# **SUPPLEMENTARY RESPONSE TO SUBMISSIONS REPORT**

Atlassian Central  
8-10 Lee Street, Haymarket

Prepared for  
**VERTICAL FIRST PTY LTD**  
5 August 2021

Figure 1 Proposed area relating to design modification condition (DA-10B-G03-01)

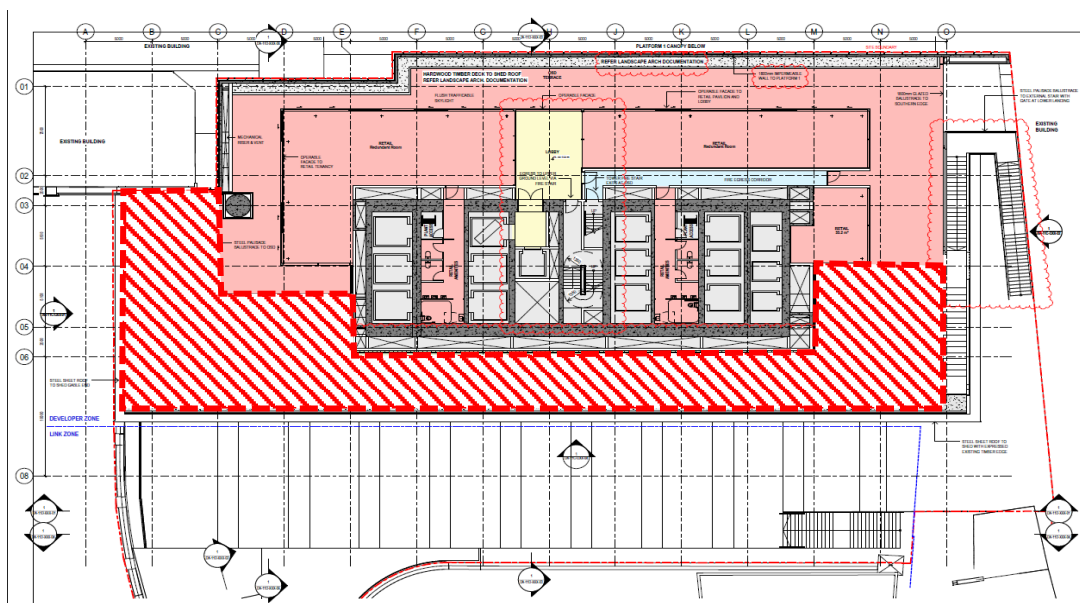
DPIE Comments		Response
Heritage		
1	Further consideration should be given to addressing the ongoing concerns of Heritage NSW and Council regarding the Inwards Parcels Shed roof and Council's ongoing concerns about the proposed reconstruction of the existing arches fronting Ambulance Avenue with a single wide arch.	<p>A response to each of the two key items is provided in the following sections:</p> <ul style="list-style-type: none"><li>▪ <b>Section 2.1.1</b> – Former Inwards Parcels Shed Roof and</li><li>▪ <b>Section 2.1.2</b> – Ambulance Avenue Heritage Wall</li></ul>

The design of the western component of the Former Inwards Parcels Shed Roof, including the proposed bleacher seating has been the subject of ongoing feedback from various stakeholders including Heritage NSW, Council as well as the Design Integrity Panel (DIP).

While this element is a minor design item relative to the overall SSDA, its importance in ensuring a balanced approach to European Heritage, Designing with Country and environmental wind conditions is critical. To enable further consultation on design development on this aspect of the development, we recommend this is be managed by a Design Modification Condition.

Prior to the release of the Construction Certificate for Stage 6 the design of the western component of the former inwards parcels shed roof (as identified on DA-10B-G03-01) is to be modified. The following matters are to be taken into consideration.

- (a) Design modification must, where possible, preference the retention of heritage fabric and the ability to perceive the inwards parcels shed roof form.
- (b) Evidence of consultation and endorsement of design modifications is to be provided. Consultation is to occur with Heritage NSW, the City of Sydney and the Design Integrity Panel.
- (c) Design modifications are to retain the Designing with Country principles that underpin the current design.

Figure 2 Proposed Dismantling Methodology for the Ambulance Avenue Heritage Wall

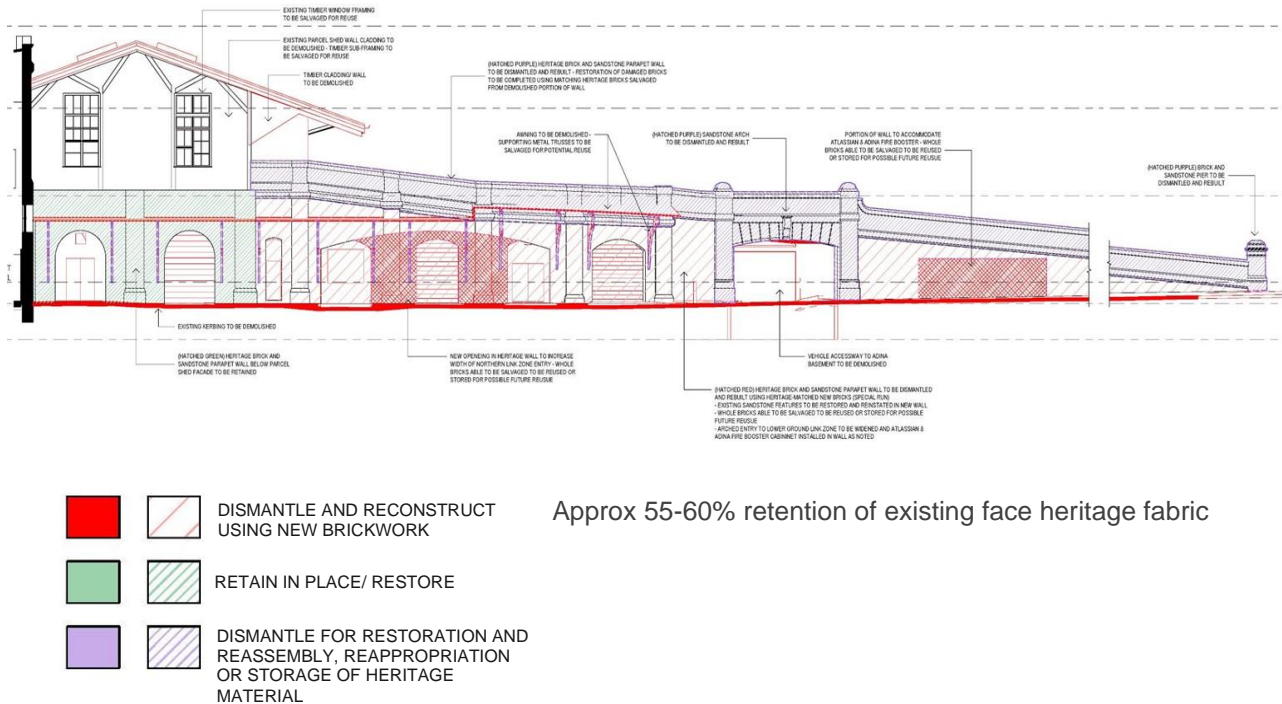
The Department are seeking further consideration to be given to addressing the concerns of Heritage NSW and City of Sydney Council with respect to the proposed reconstruction of the existing arches fronting Ambulance Avenue with a single wide arch.

We note specifically that Heritage NSW are seeking further detail on the “rationale” for these works, and how the demolition and re-use of fabric and structures will be minimised. In addition, the City of Sydney is concerned that the “scale and construction are poorly proportioned, and inconsistent with the fine classical language, fabric and detail of the retaining wall” and they “don’t support prioritising assumed pedestrian levels at 2056 +15% to the detriment of significant heritage fabric”.

- Detailed investigations by Traditional Stonemasonry Consulting have been undertaken and has been previously provided within the Heritage Building Fabric Deconstruction and Storage Report submitted alongside the RtS Heritage Response Report. In line with Figure 2 below, the report notes the difficulty that exists in dismantling the brick component of the heritage wall due to the very strong mortar that was used in its construction. The report states that it could be very difficult to remove the mortar without

damaging the majority of the bricks. As a result of this the methodology seeks the complete salvage of all sandstone embellishments and the demolition of the existing brickwork where salvaging of any bricks during this process is highly encouraged to minimise the extent of new brick manufacture.

- Urbis Heritage are satisfied that all attempts to avoid or minimise the extent of fabric to be removed or demolished have been undertaken. Heritage impacts are being mitigated through the careful salvage, conservation and reinstatement of the brick and sandstone parapet wall, as well as the sandstone embellishments along the wall. Urbis Heritage is comfortable that the original confirmation of the openings can be understood through careful interpretation and a refined approach to the reconstruction of this wall to clearly delineate between old and new.

Based on the above analysis, it is proposed to maintain the existing design for Ambulance Avenue as per the RtS. Whilst Atlassian recognise the importance of sensitively managing the heritage impacts associated with the arches on Ambulance Avenue, this needs to be balanced with the public infrastructure requirements to ensure the Western Gateway Precinct can meet the needs of the public both on completion and into the future.

Figure 3 Examples of Wind Mitigation Measures

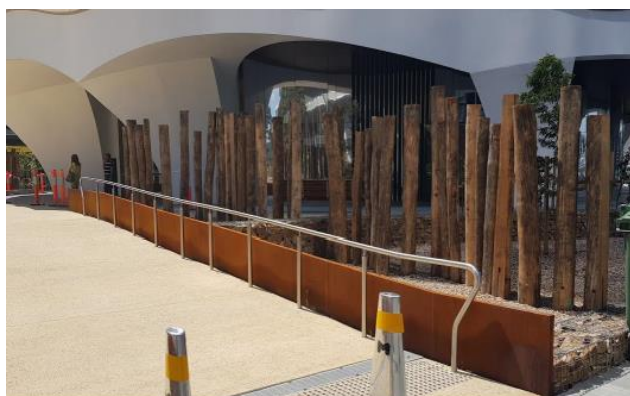
DPIE Comments		Response
<b>Wind Impacts</b>		
2	<p>Provide an options analysis of any additional mitigation measures which could be implemented within the proposal (rather than Blocks B and C) to</p> <ul style="list-style-type: none"> <li>▪ meet comfort levels for sitting in the future 'Central square' and a minimum 200 m2 area within Railway Square as required by the Western Gateway Sub-precinct Design Guide</li> </ul> <p>address areas which do not meet the safety criteria established by the Western Gateway Sub-precinct Design Guide in day 1, 2 and 3 scenarios.</p>	<p>With respect to both Railway Square and Central Square, the proposal complies with the comfort criteria in the required areas under the WGDG in all scenarios – refer to Image 2a, 2b and 2c of the Wind Memo prepared by RWDI at <b>Appendix A</b>.</p> <p><b>Section 2.2.2</b> below addresses the proposal in relation to the established safety criteria within the WGDG.</p> <p>Temporary Mitigation Strategies are proposed in relation to the safety criteria and are address in detail at <b>Section 2.2.3</b>.</p>

DPIE Comments	Response
<ul style="list-style-type: none"> <li>the appropriateness of the wind mitigation measures from a design and visual impact perspective</li> <li>the ability to provide wind comfort appropriate for the intended use of the bleachers.</li> </ul> <p>If an appropriate heritage, design and wind comfort/safety level cannot be achieved consideration should be given to removing the bleachers from the proposal.</p>	<p>this space should the trafficable component be retained.</p>

The importance of a safe and comfortable wind environment throughout the public domain is acknowledged and all parties within the western gateway sub-precinct are working collaboratively to achieve the outcomes required by the Western Gateway Design Guide (WGDG). It is however noted that with a continually changing wind environment within the Western Gateway sub-precinct, that we are not able to solve every outcome with one solution.

- With the temporary localised mitigation measures proposed below, the development will not result in any exceedance of safety criteria in a Day 1 or Day 2 scenario.

Figure 4 Selected Views for Photomontages

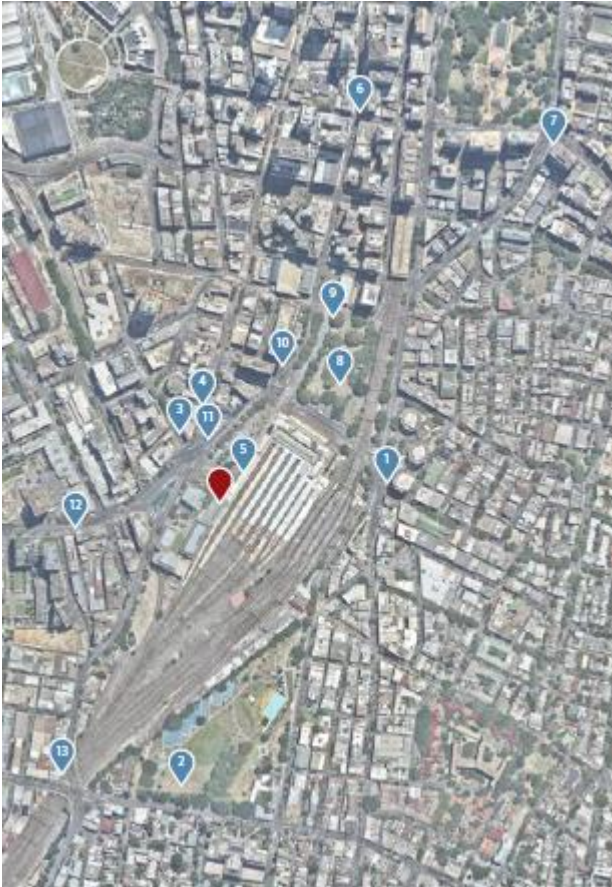
***We acknowledge the Heritage Setting View Analysis report has been updated to include the two other significant multi-storey developments proposed for the Western Gateway sub-precinct. However, we request that a further visual analysis be undertaken to provide a more holistic analysis of all views including looking from the south (from Broadway) and from the east (from Prince Alfred Park) to the proposed development. This will allow a clearer understanding of the visual impacts of the proposed development.***

Views looking to the north-east (from Broadway) and views looking to the north (from Prince Alfred Park) are addressed within the Visual Impact Assessment (VIA) submitted with the EIS. Figure 3 below indicates a view point location map from the VIA, where views 12 and 2 represent views that would be available from parts of Broadway and Prince Alfred Park, respectively. The fully rendered views included in the Heritage Setting Views Analysis report should be considered in conjunction with the the full range of views included in the VIA. In our opinion the selection of view places and views modelled provide an adequate representation of the likely changes that would occur subsequent to the approval and construction of the built form proposed.
